SUBJECT: Forwards legible copies of certain pages from 51 potential finding repts, in response to 820209 request. Repts originally transmitted on 820129, 0204 & 05.

Subject: Docket 50-361 and 50-362
San Onofre Nuclear Generating Station
Units 2 and 3

2408-PFR-0009

CALC. NO. C270-01-E

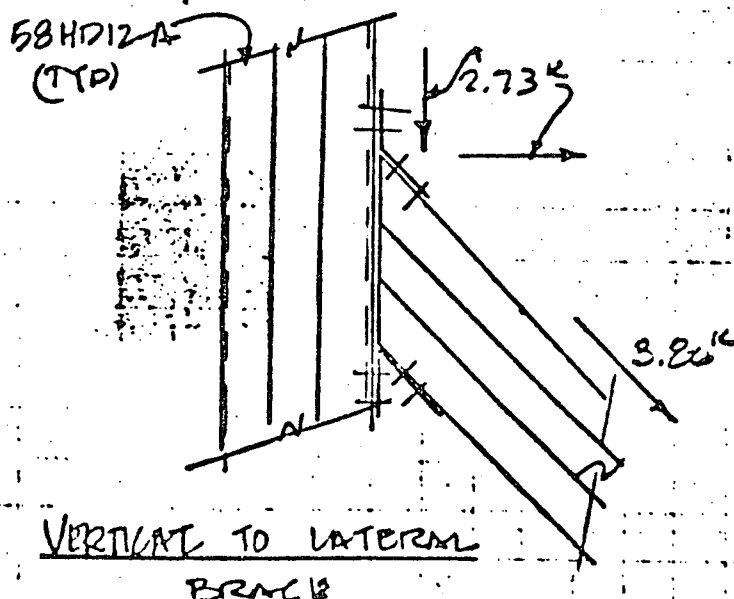
Request: Provide more legible copy of BPC calculation sheet (lower right hand corner).

Response: More legible copy attached.
